## QUALITY ASSURANCE -- NON-CONFORMANCE REPORT

**Report No:** NCR-000685

**Reference Description:** The welder was not using his qualified weld process/position while performing base metal repairs on Segment 8AE Deck Panel

**Dear:** Mr. Charles Kanapicki  
**Job Name:** SAS Superstructure

Draft of welding discontinuity:

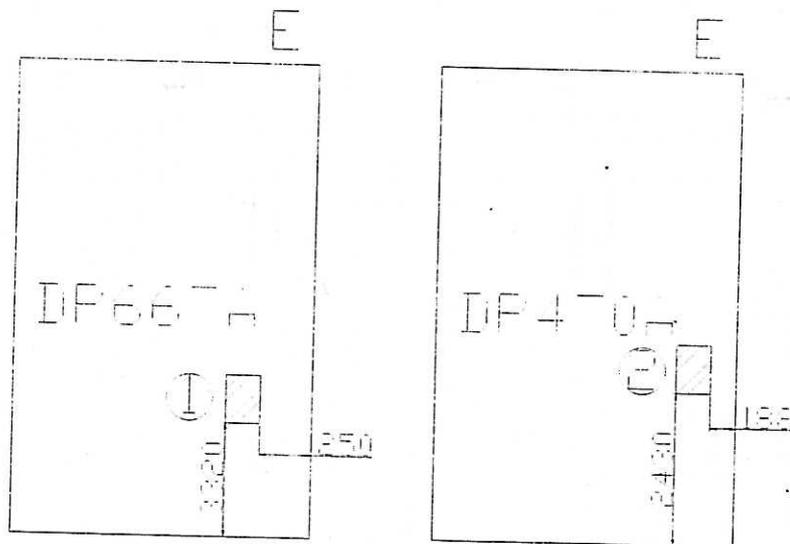
经检查发现8AE箱梁顶板DP667A/DP470A在进行母材返修时, 未按正确返修工艺程序进行, 现要求将不合格焊缝去除后, 重新返修。1. L=24mm 2. L=18mm, 具体位置见下图!

After inspection 8AE box deck plate DP667/DP470A, repair base metal didn't according to technology procedure, and remove unaccepted weld and repair, 1. L=24mm 2. L=18mm, the detail position sees the following draft.

Worker operated error caused base metal gouged.

1. QC and CWI should be present to witness the repair, direct and supervise all repair operations during this repair to ensure the repair is per the disposition requirements, and the AWS D1.5 code requirements.
2. Grind the repair area to a smooth finish according to the approved repair WPS.
3. Prepare the joint according to the approved WPS.
4. Notify QA verbally prior to NDT. Perform 100%MT and 100%VT of the repair area.
5. Remove all defects by grinding to ensure all defects are completely removed if defects still exist, and repeat "step 4" to assure complete removal of all defects if necessary.
6. Clean the repair area of all loose debris including MT powder.
7. Preheat and weld according to the approved WPS.
8. Grind the weld flush after welding.
9. Notify QA verbally prior NDT. Perform 100%MT and 100%VT of the repair area.
